DA 2023/1908
41 Robertson RD Scotland Island.

Having recently become aware of this DA, would like to submit an objection to the current application on the following grounds. We are the neighbouring property 39 Robertson Rd.

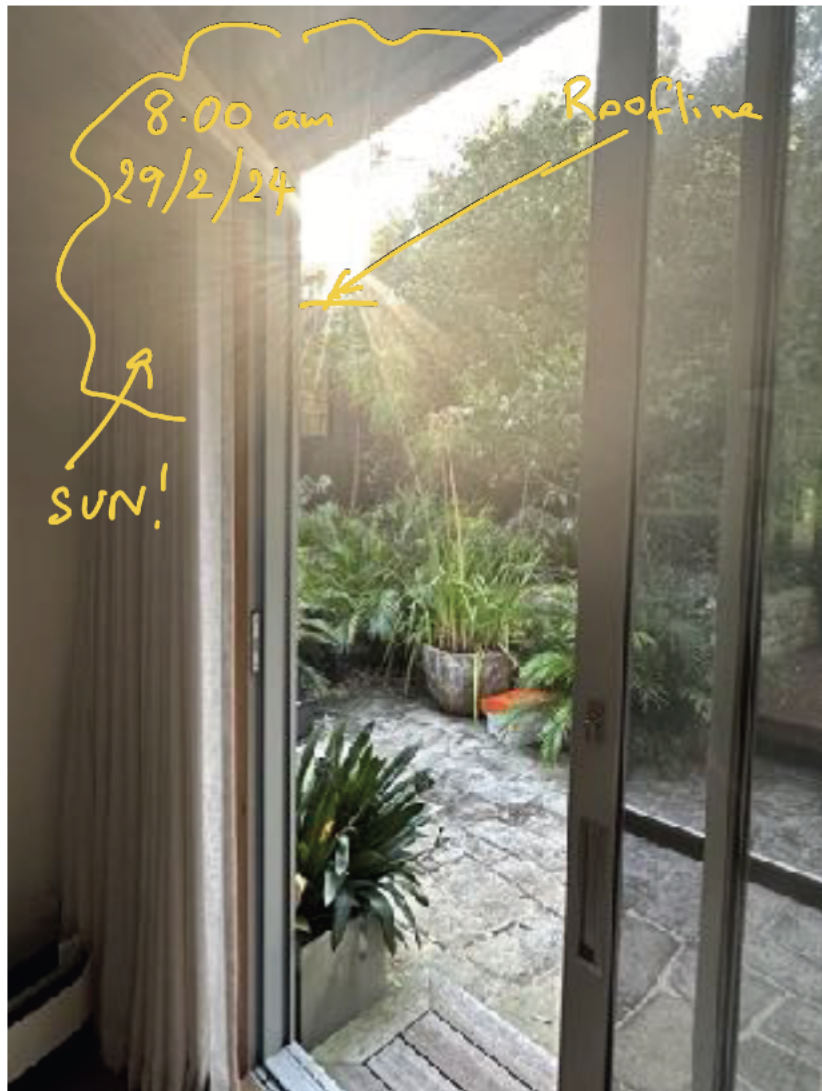
It is too hot to sit on our northern deck due to heat radiation from the masonry walls, we cannot leave doors or windows open in summer to the north for breezes due to the heat from our neighbours building. This will be worse if another level was to be constructed.

There are issues with wind funnelling through this area due to channeling of wind and the height of the current building to our north.

The ambient temperatures recorded by a thermometer, in an open outdoor area read 5* hotter on our boundary to the north, than in an open outdoor area away from the building.
